**UMMC PROJECT NO. 209-587
MIND CENTER AND GERIATRIC CLINIC
UNIVERSITY OF MISSISSIPPI MEDICAL CENTER
JACKSON, MISSISSIPPI**

Addendum No. 1

October 27, 2025

This addendum forms a part of the contract documents and modifies the original plans and specifications dated September 17, 2025.

sheet no.
A-701

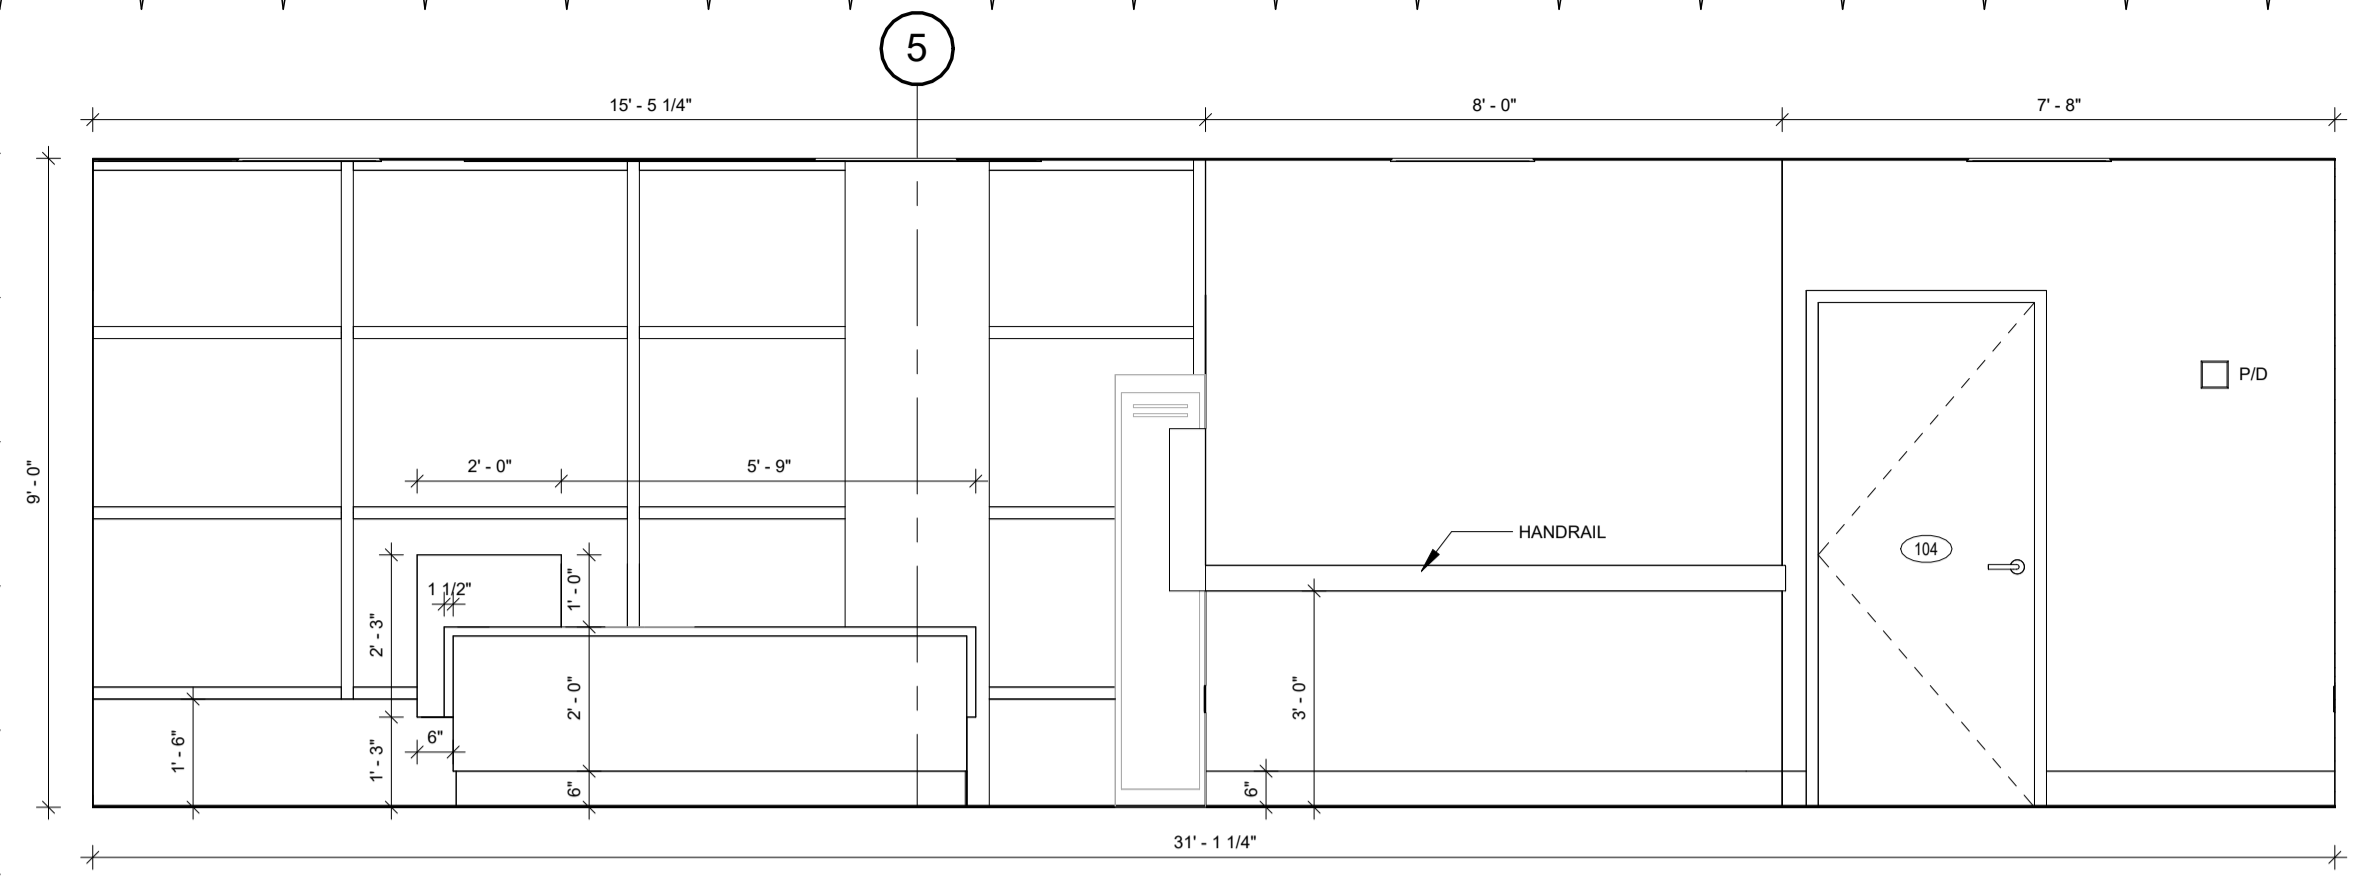
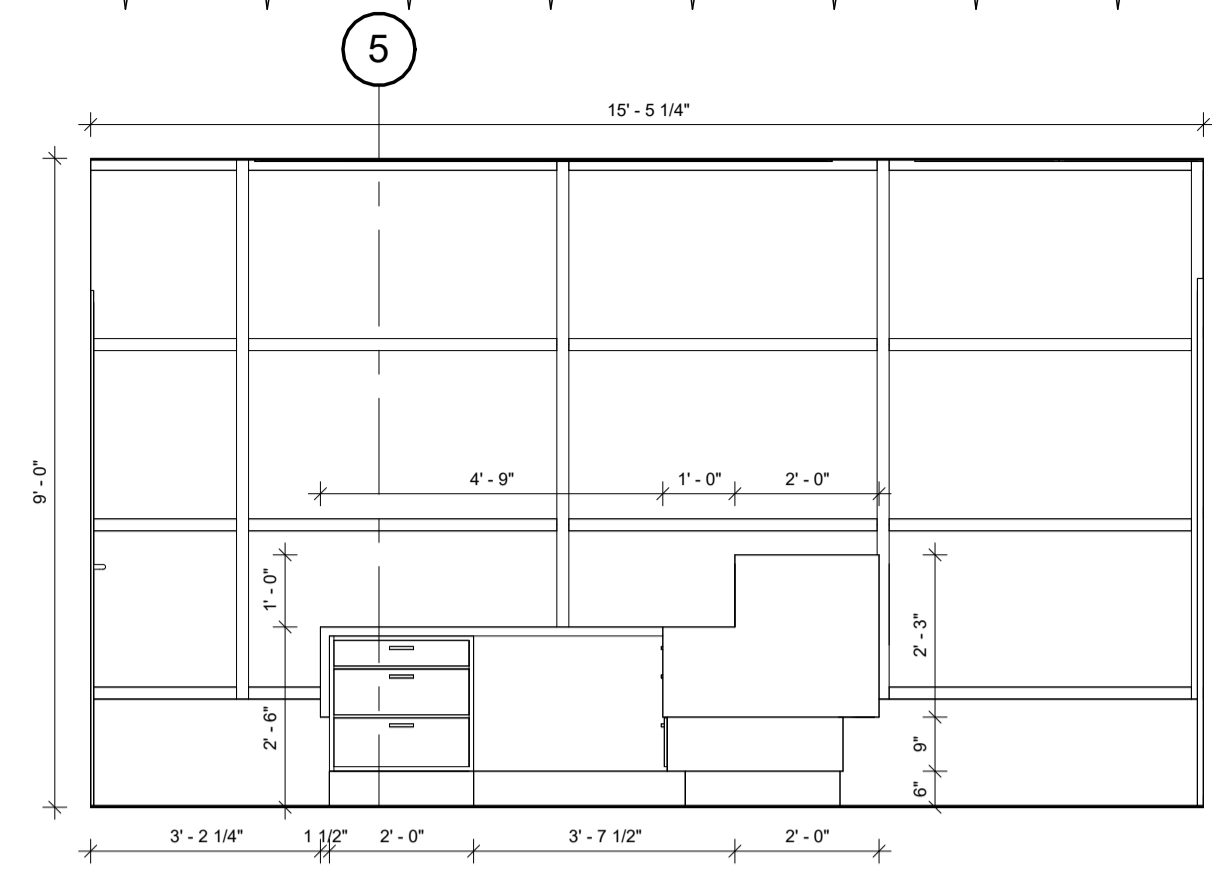
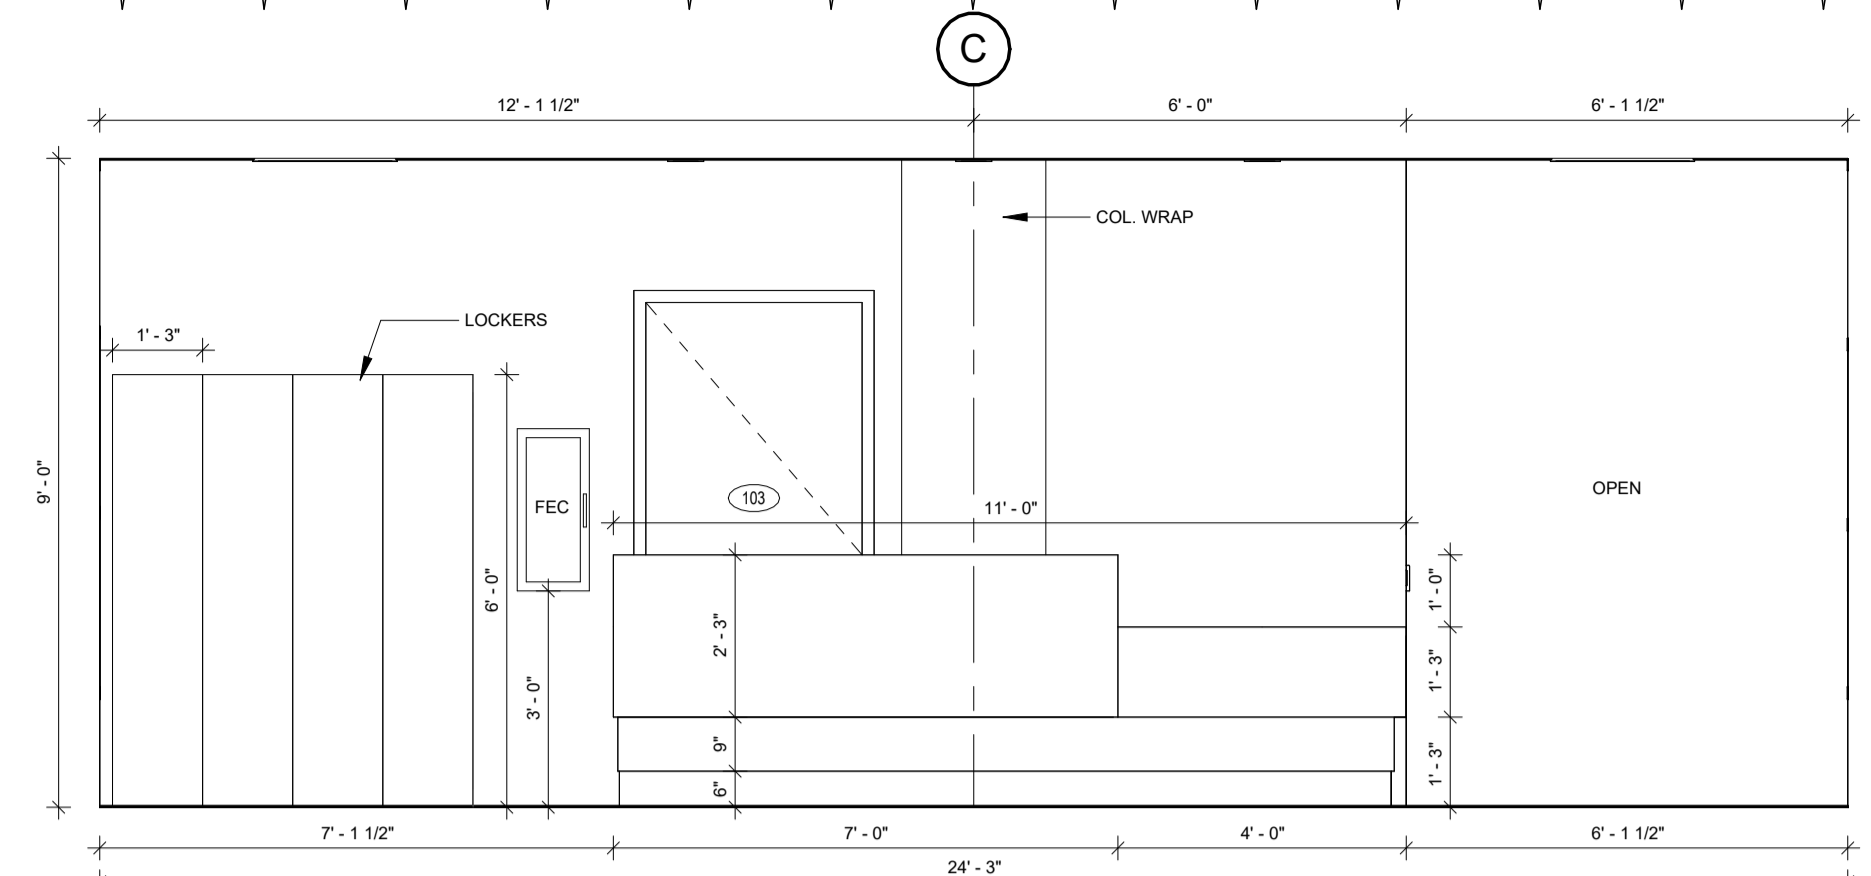
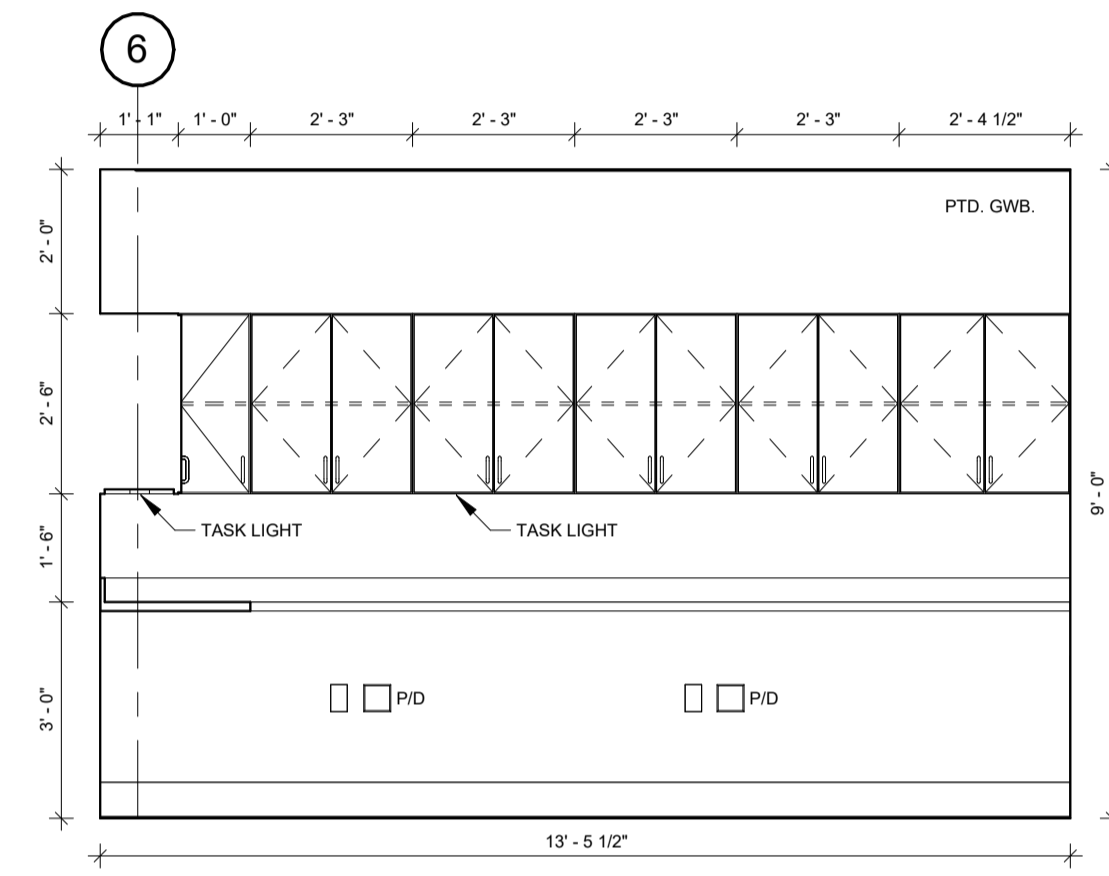
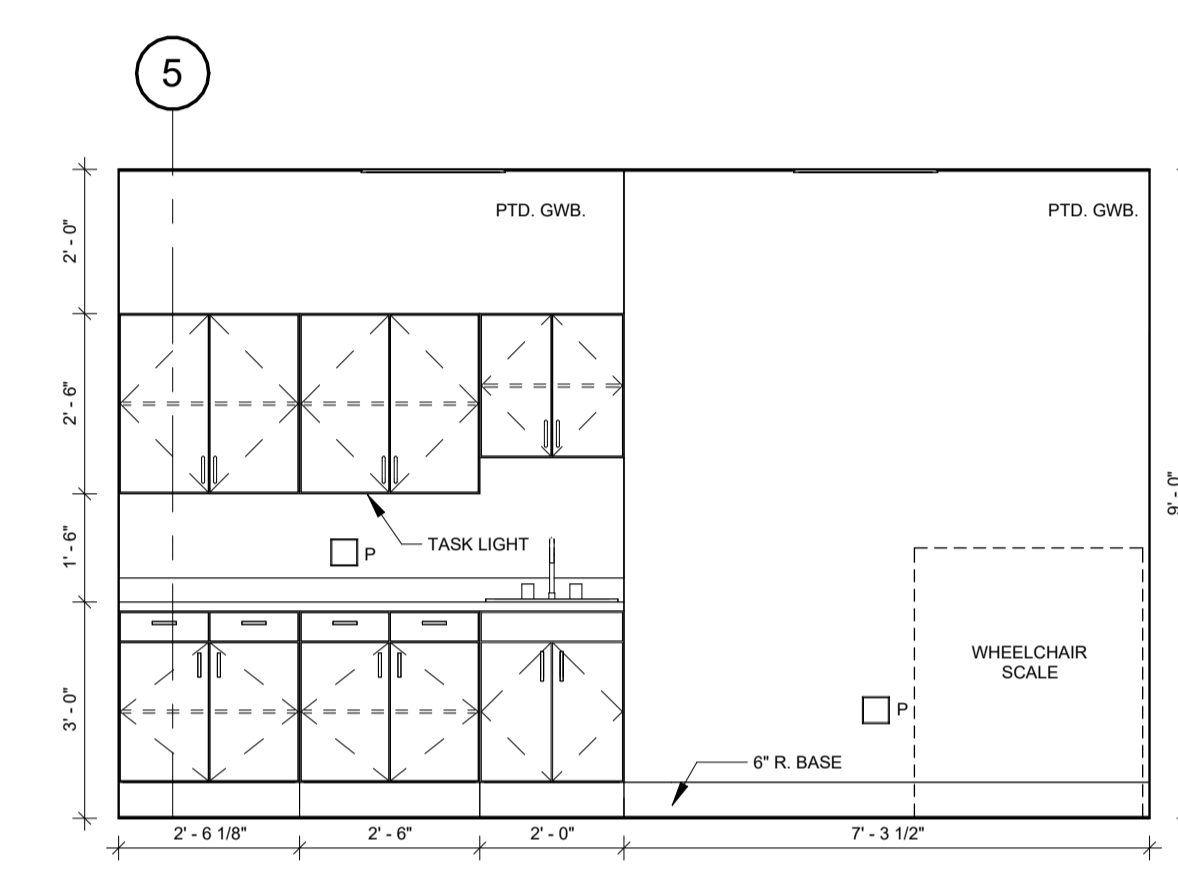
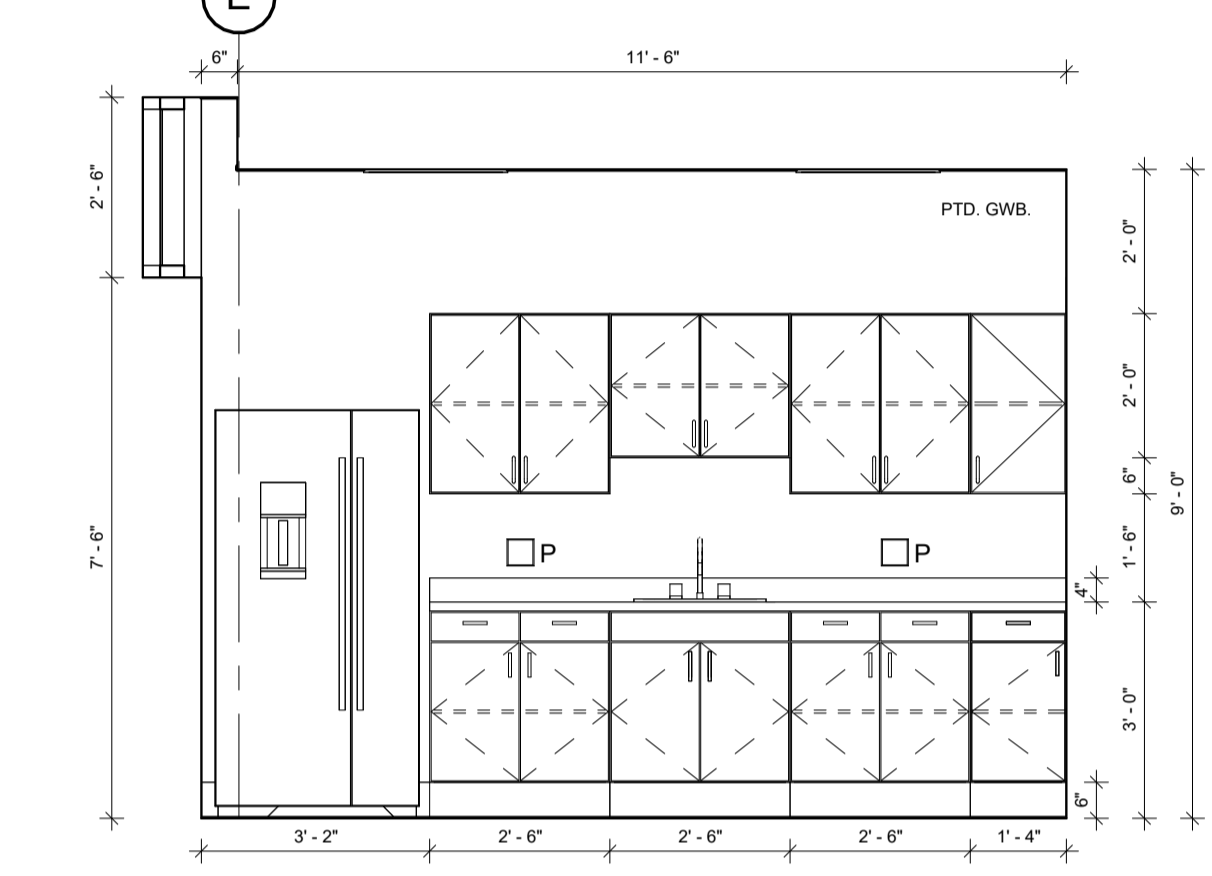
Replace: The existing sheet with the enclosed revised sheet A-701.
